Application by RiverOak Strategic Partners Limited for an Order granting Development Consent for the reopening and development of Manston Airport in Kent

REQUEST FOR COMMENTS AND FURTHER INFORMATION

Response by No Night Flights to the Department for Transport letter dated 17th January 2020 – NNF25

RSP Map 12.6 – Aircraft Noise Day-time LAeq 16hr contours, year of forecast maximum capacity

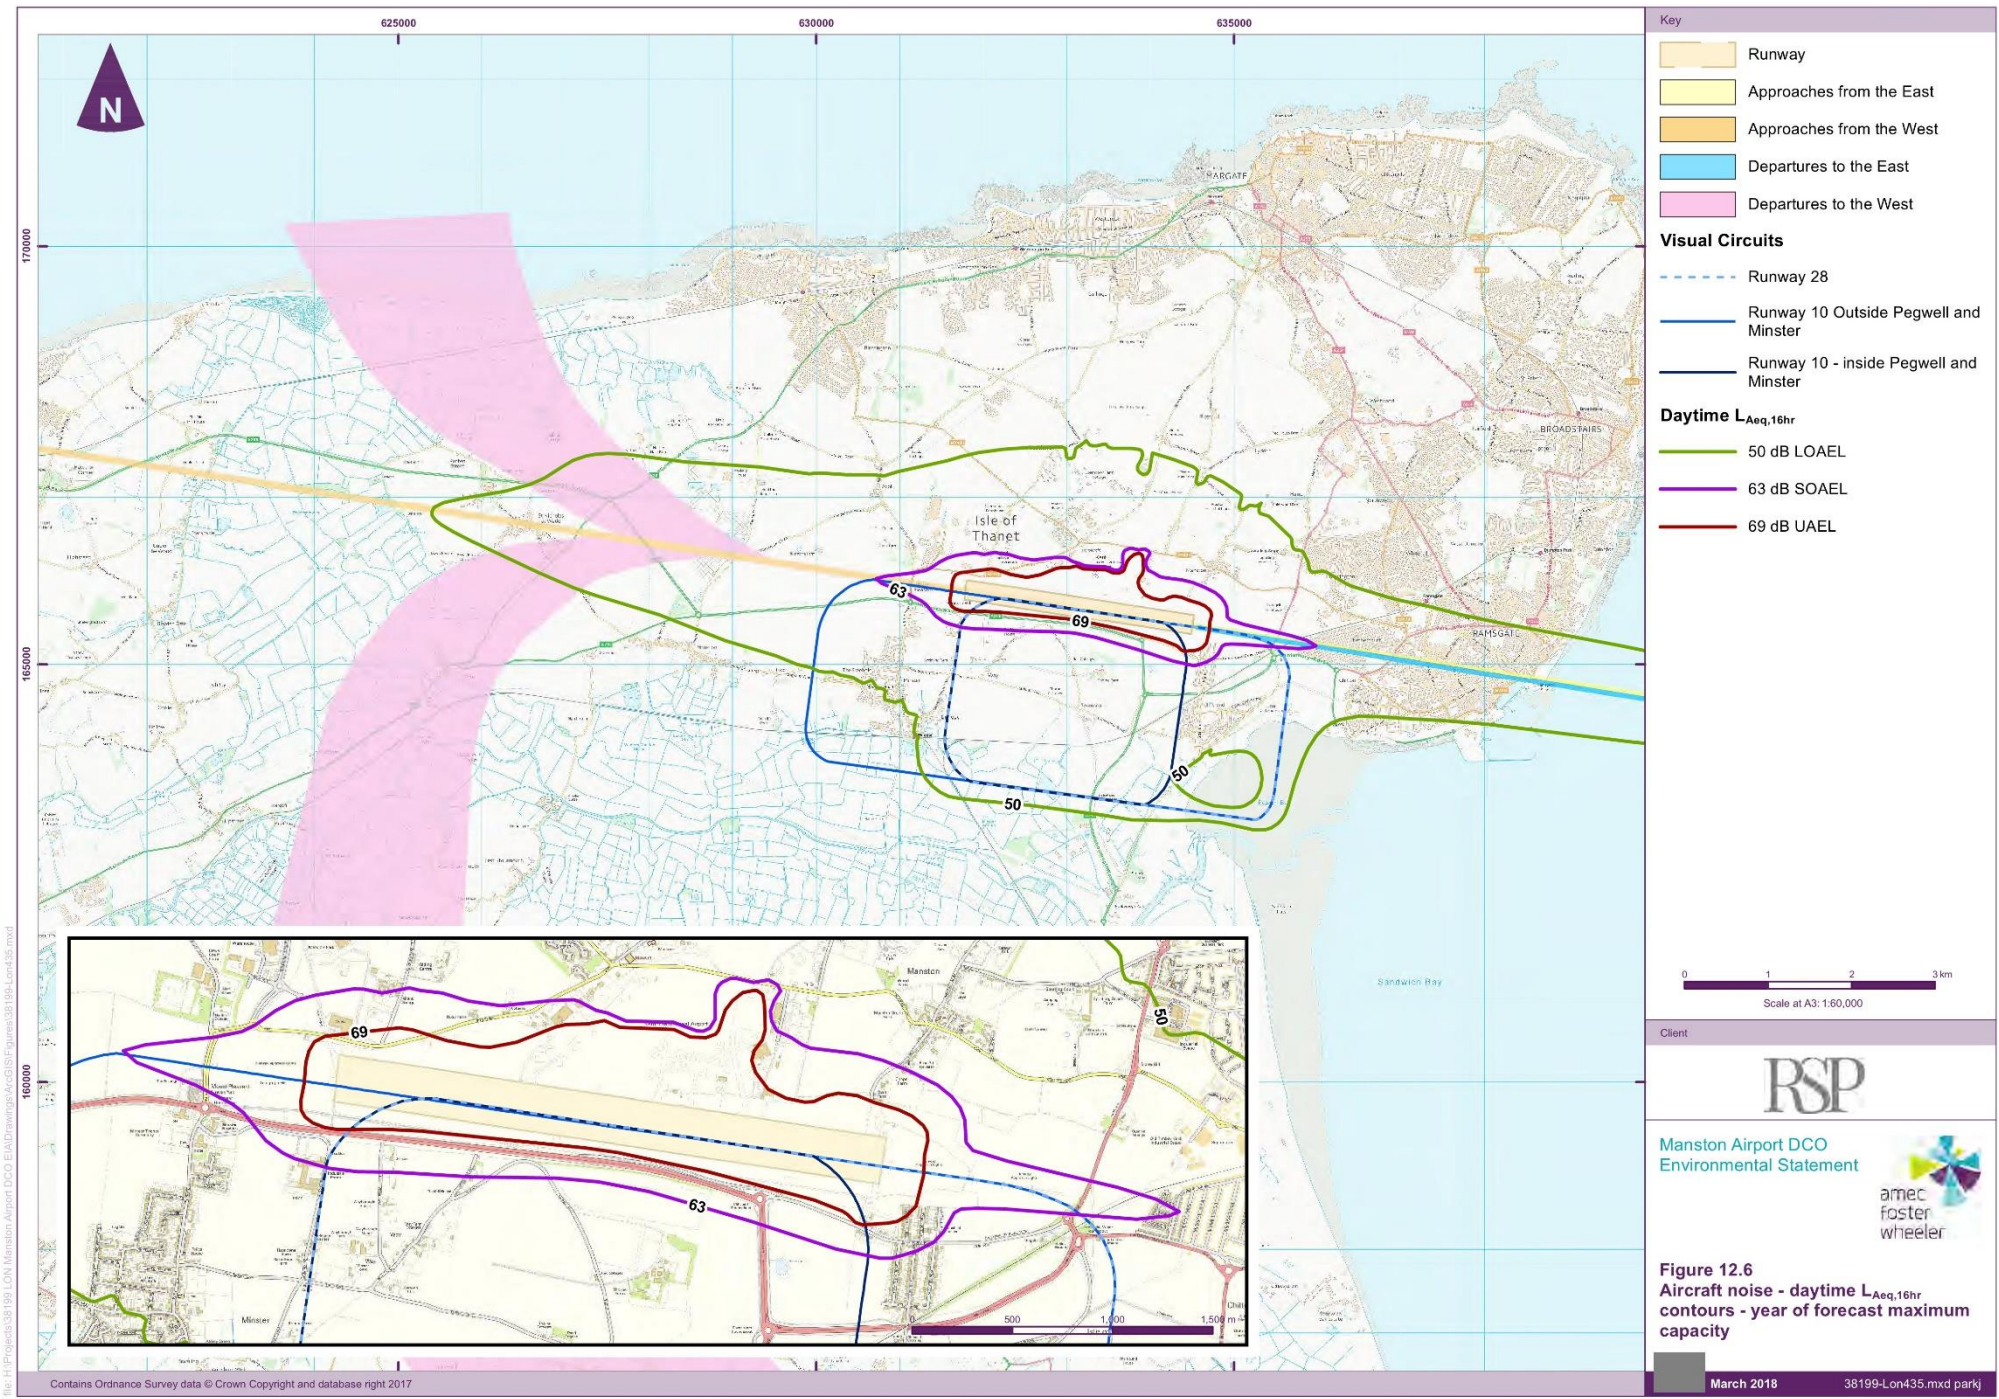
65. The best comparator that we can find for our Map 6 is RSP's Figure 12.6 (see page 70) – daytime LAeq 16 hour, Year 20. Of course, RSP has averaged operations to the east with operations to the west. This means that the noise impact is considerably understated in RSP's contours. RSP's 50dB contour over Ramsgate falls slightly outside the CAA's 57dB LAeq contour and between that contour and the CAA's 54dB LAeq contour. The CAA's contour map shows that between 29,100 and 37,950 people²⁶ will experience average noise levels over 54 dB LAeq. That is the level of the onset of significant community annoyance. RSP is seeking to downplay this. RSP is not proposing to offer any mitigation.

77. Again, the contours in Map 8 are larger than the contours in RSP's Figure 12.6 from its ES (see page 70). In Ramsgate, RSP's 50dB LAeq contour falls partly inside the CAA's 51dB LAeq contour and then runs with the CAA's 54dB LAeq contour to the north.

RSP Map 12.7 – Aircraft Noise Night-time LAeq 8hr contours, year of forecast maximum capacity

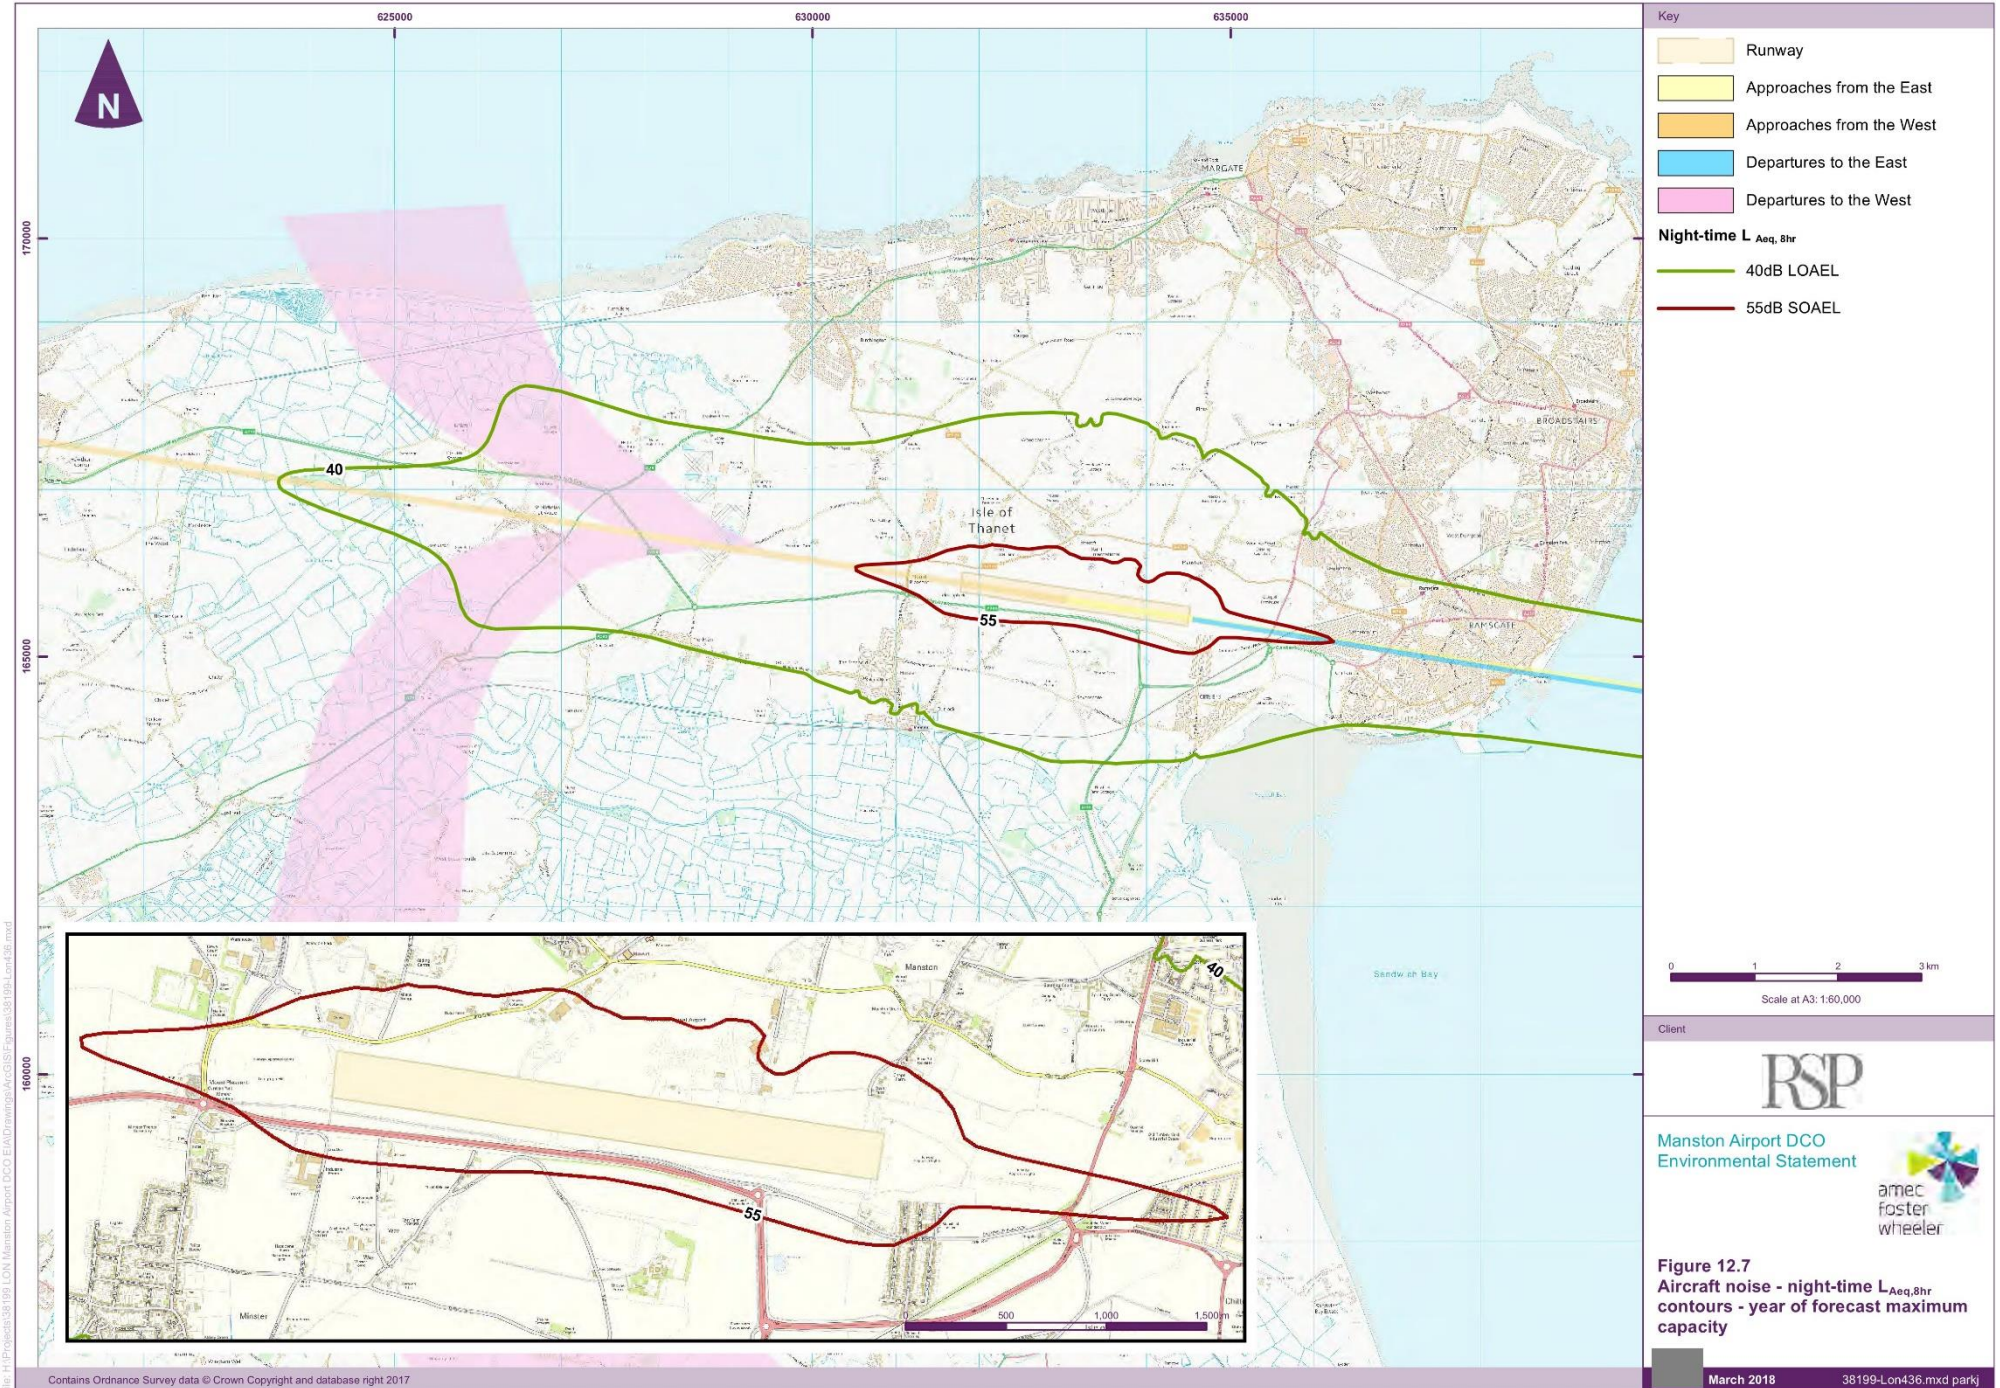
92. RSP's night LAeq contours are in the ES at Figure 12.7 (see page 71). It is hard to know how RSP calculated these contours given the confusion amongst the RSP team when asked at the ISH on Environmental Issues in June what underpinned its night operation assumptions and what fleet mix and number of ATMs led to RSP's desire for a 3,028 annual QC budget. It can be seen from RSP's Figure 12.7 that RSP has significantly understated the potential noise impact of the night flights that it could operate whilst staying within its desired QC budget and whilst following its statements about welcoming late arriving cargo planes at night and allowing passenger planes to take off from 0600.

93. RSP has shown only the 40dB and the 55dB night contours. Looking at Map 10 above, RSP's 40dB contour is smaller than the CAA's 45dB contour in the west and is closer to the CAA's 48dB contour. Looking at Map 11 above, RSP's 40dB contour is similar to the CAA's 45dB contour in the east. RSP's Figure 12.7 disguises the fact that the 57dB Lnight contour stretches well into Ramsgate and that much of the town would experience average night noise of 51dB.

RSP Map 12.9 – Aircraft Noise Night-time LASmax contours, year of forecast maximum capacity

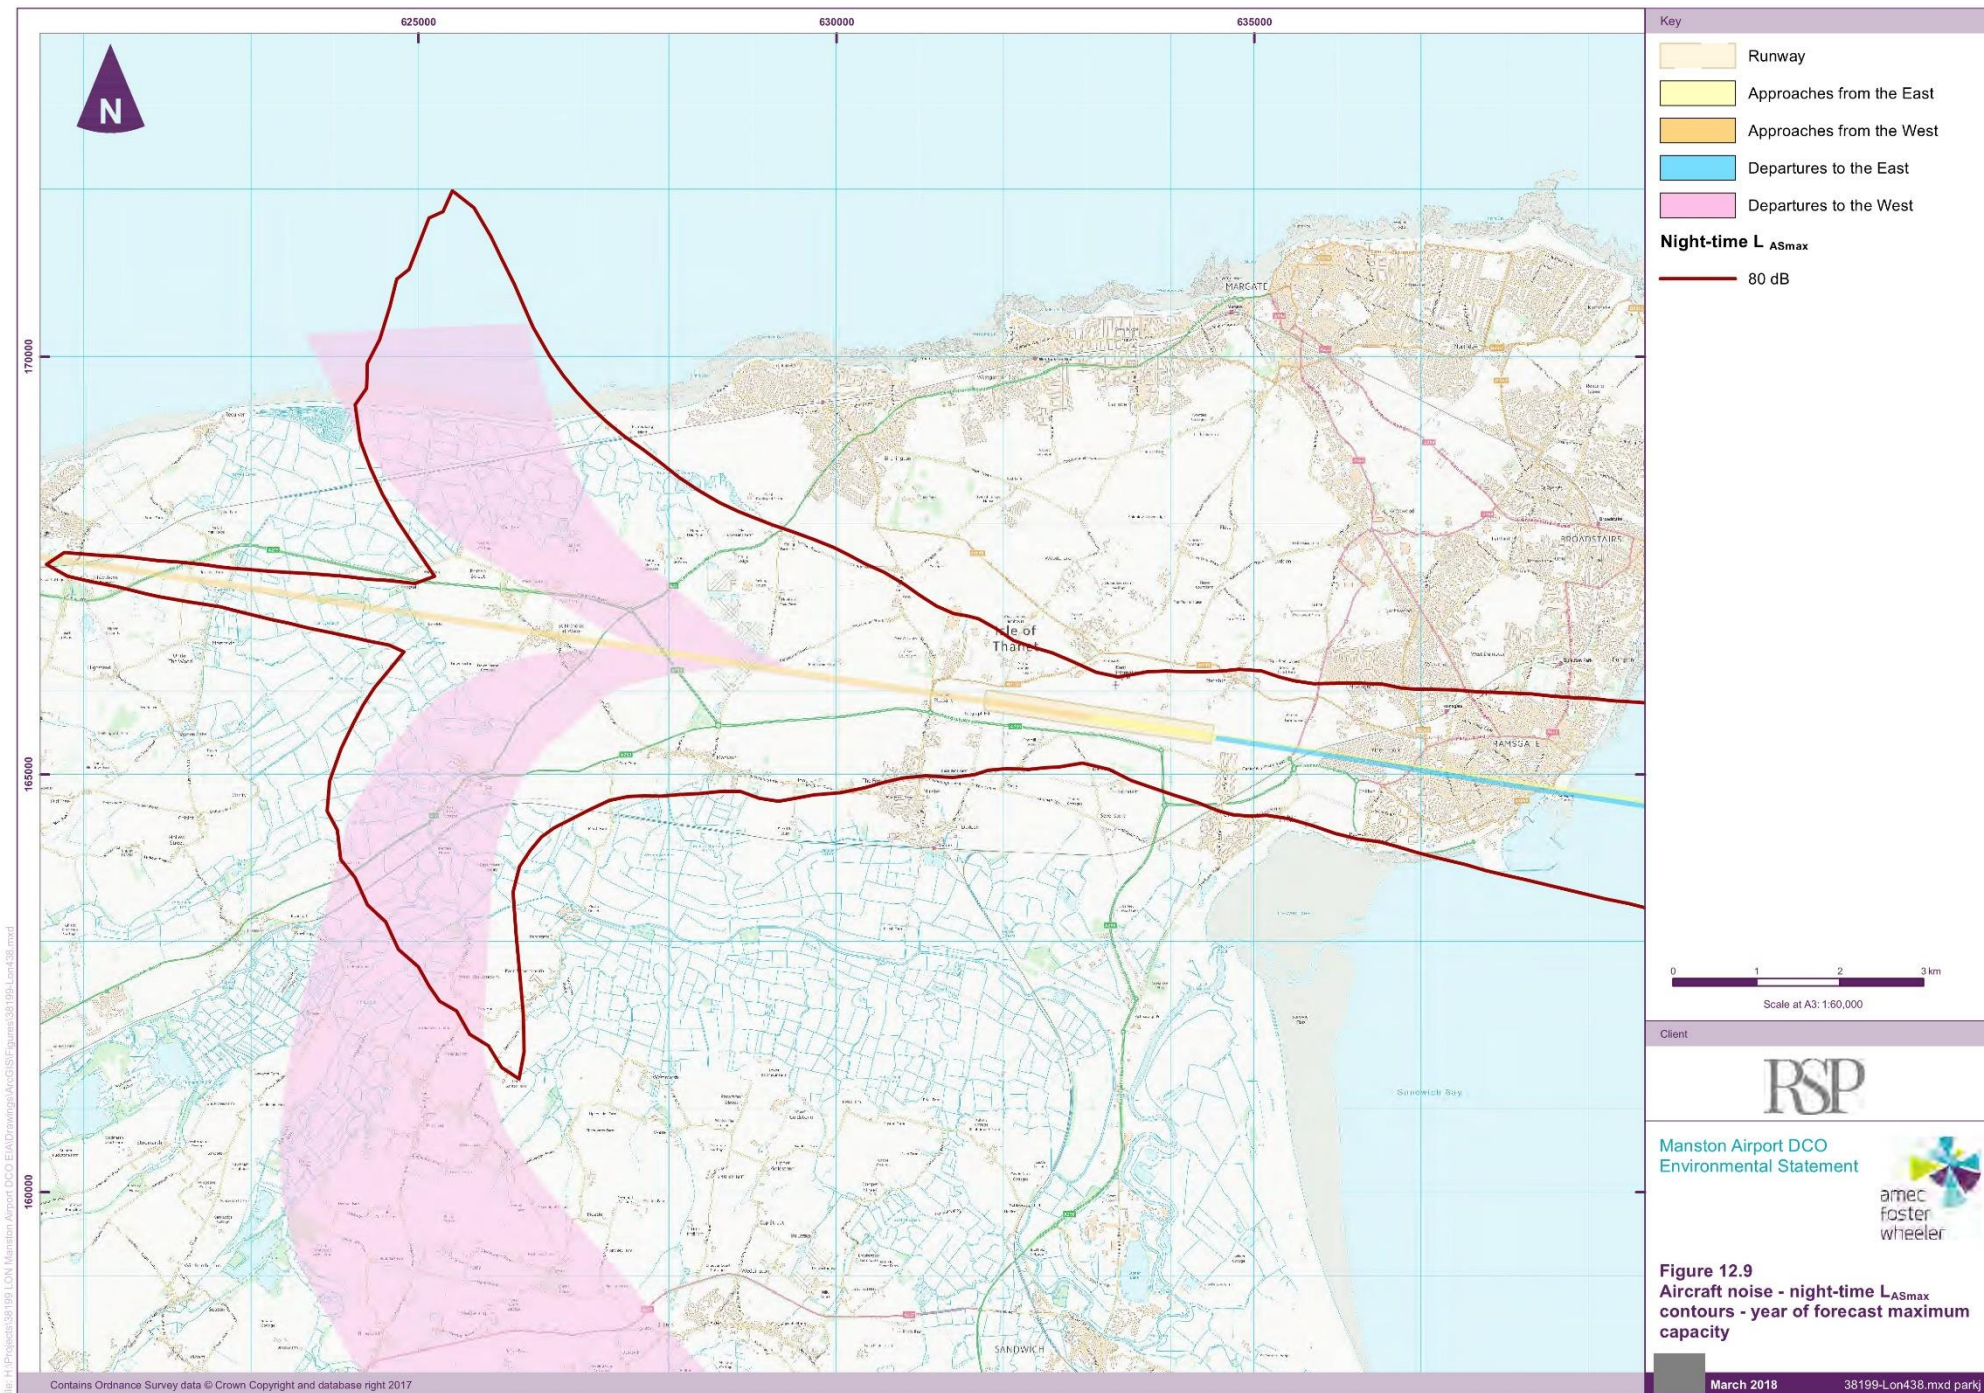
- 56. A comparison of RSP’s Figure 12.9 (page 72) with NNF’s Maps 1 and 2 reveals a significant noise impact that RSP has simply not shown. The 70dB contours extend over the entire town of Herne Bay in the NNF contours. RSP has only modelled 80dB LASmax and so Herne Bay does not even appear on its maps. This suggests that Herne Bay will be entirely unaffected by aircraft noise – an assertion often made by the RSP team at various consultation events. However, Herne Bay residents know from experience that a single 747-400 creates a significant noise footprint. A 747-400 overflying Herne Bay in the daytime is loud enough to make people look up as it goes over. At night, the impact is greater. The real impact on Herne Bay residents is entirely missing from RSP’s assessment of noise impact.
